ADDENDUM NO. 1

Date: 7/24/23

Issued by: Sacramento City Unified School District

Project: Project #: 0510-433  
CKM CCTV Cameras

T000

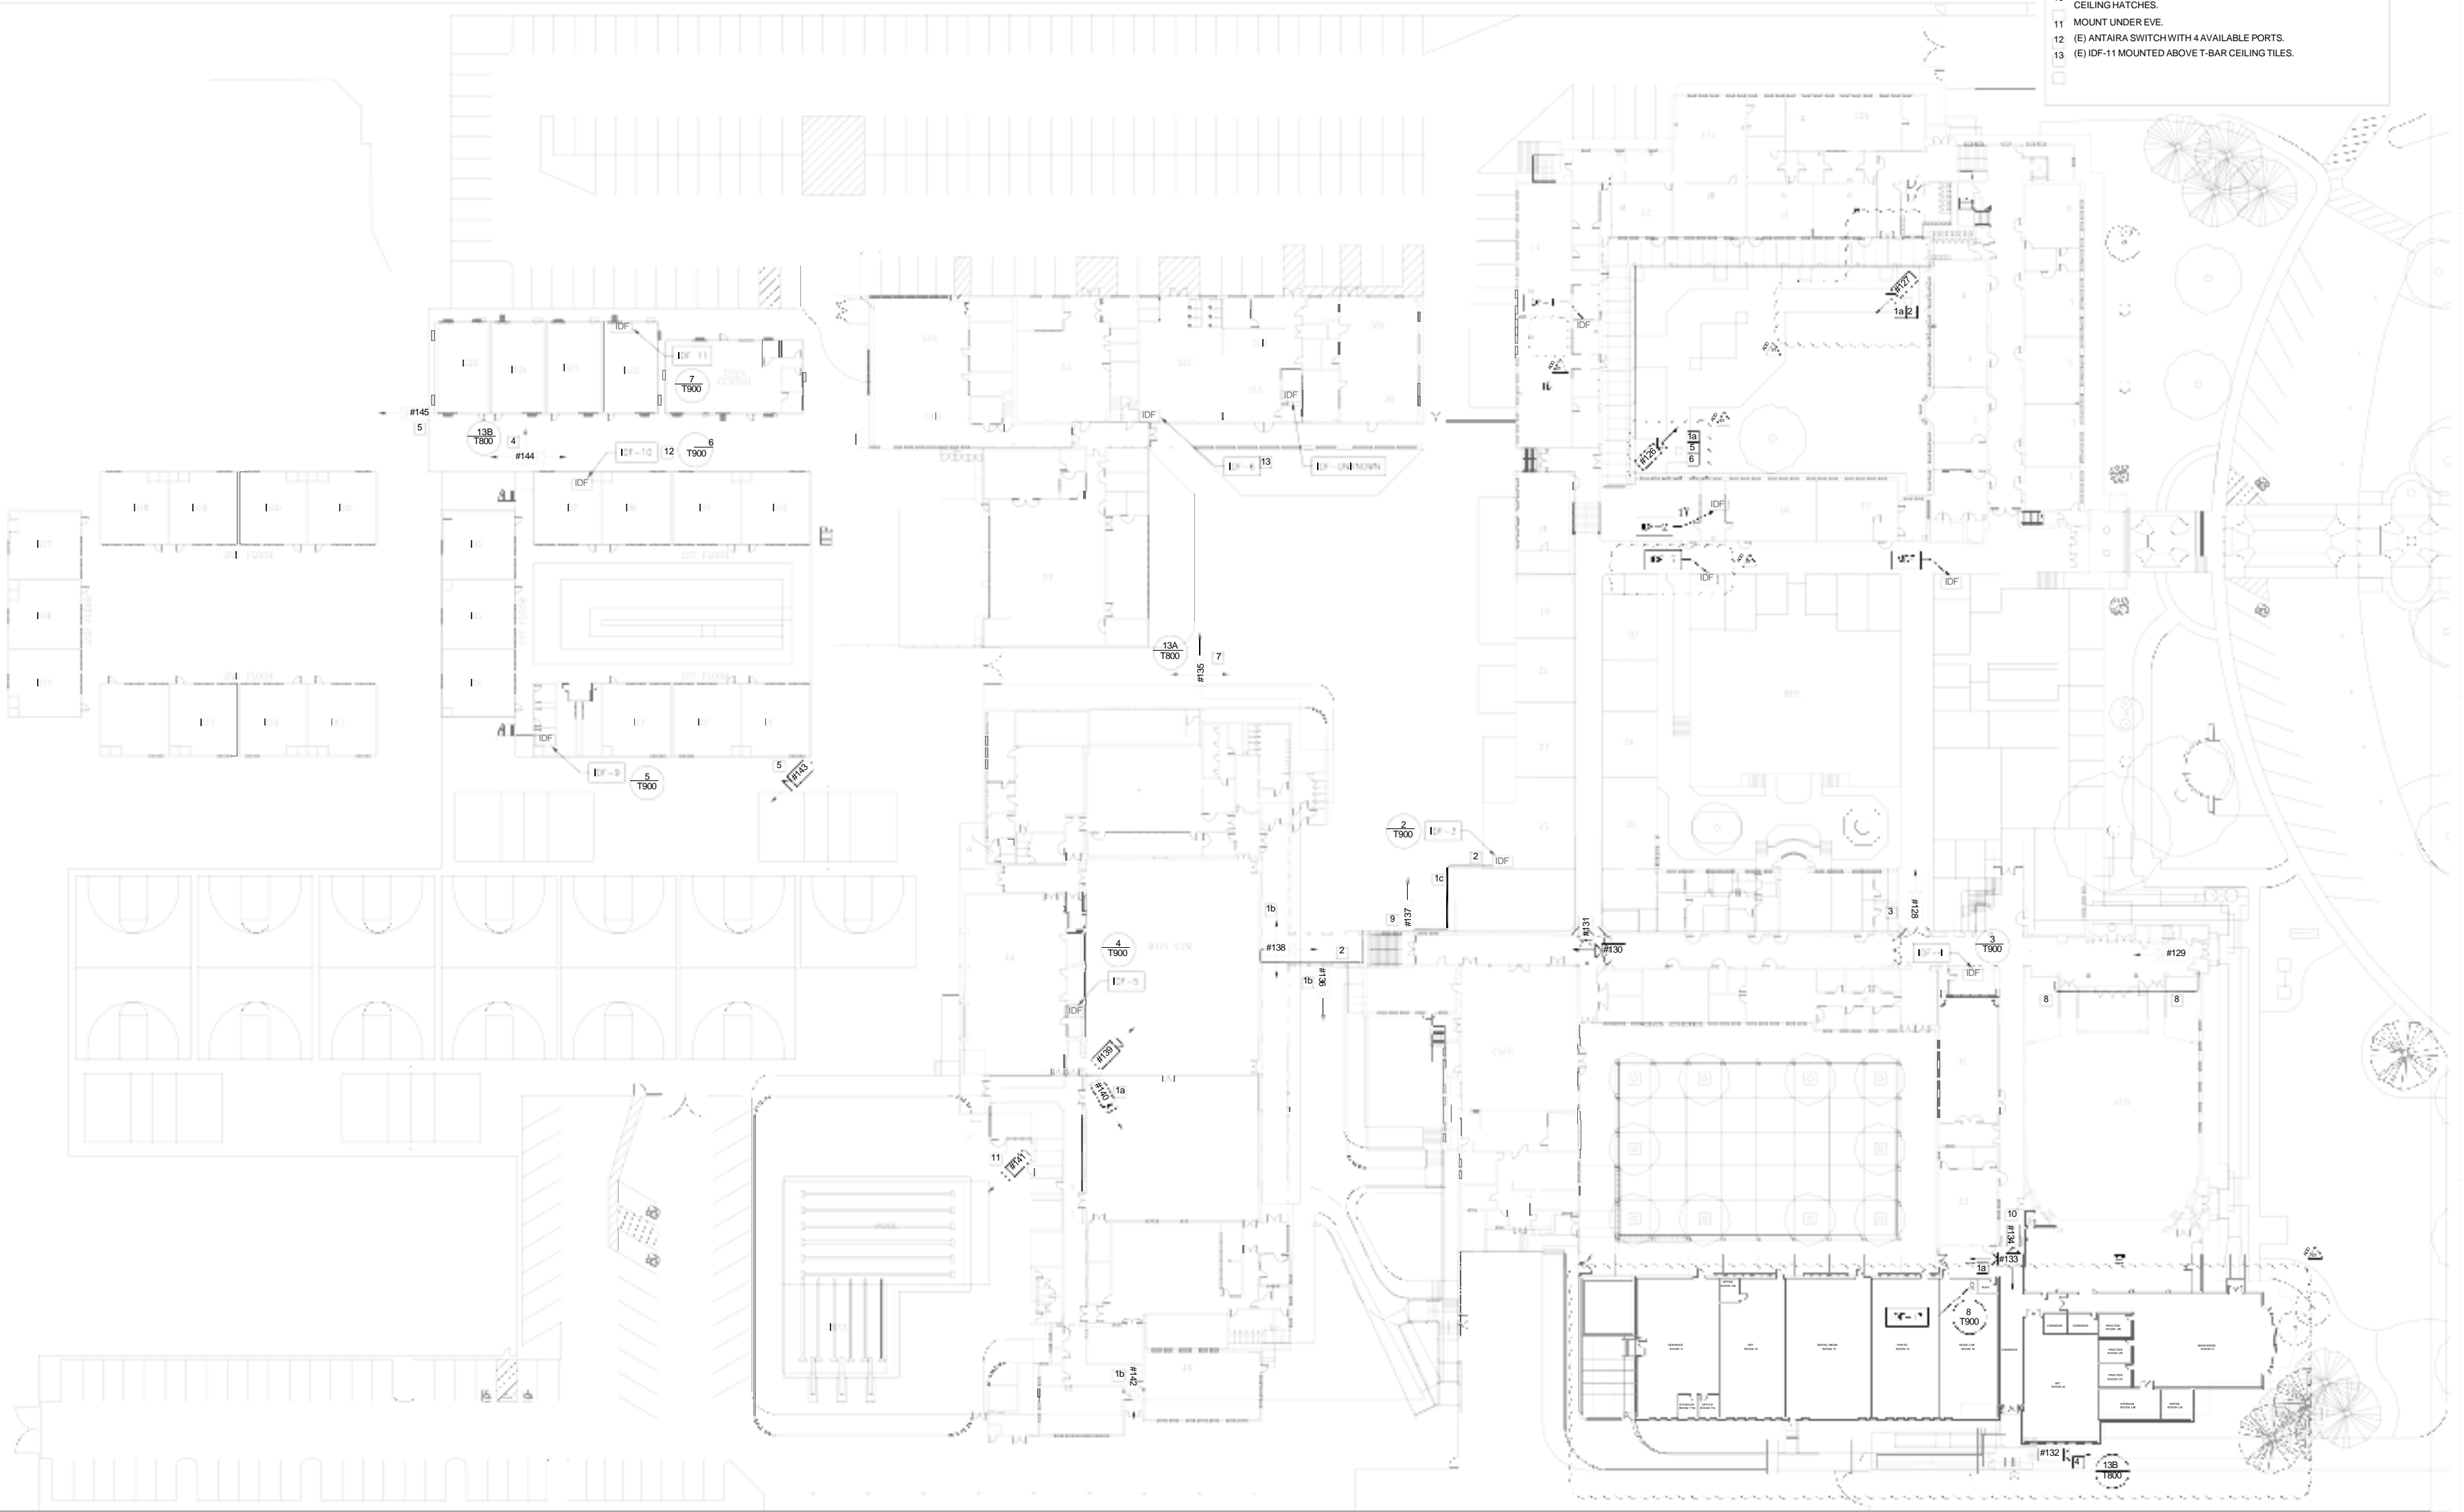
15. Sheet T000, CCTV Symbols and Notes, attached,
  - a. Revise sheet as shown.
16. Sheet T100, CCTV Site Plan, attached,
  - a. Revise sheet as shown.
17. Sheet T800, CCTV One-Line and Details, attached,
  - a. Revise Detail 1 Camera IP/ Descriptions as shown.
18. Sheet T900, CCTV Picture Details, attached,
  - a. Revise details 1 (deleted), 3, 4, 6 and 8 as shown.

SHEET  
**T800**

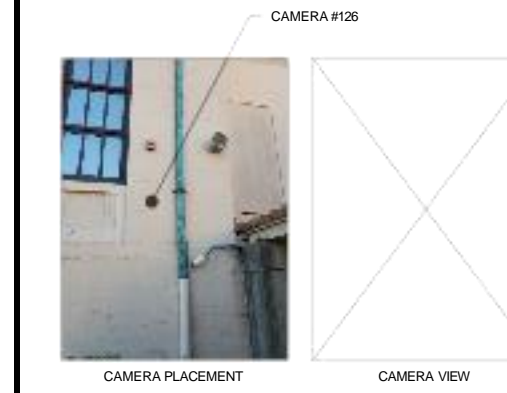
9. Camera #132 says it's a single sensor on the camera list but the sheet notes state replace with corner mount multi-view. Please clarify what is needed.

Answer: Camera #132 shall be an Exterior Rated IP Camera, Multi-Directional (3x4MP Sensors), i-PRO WV-S8543LG
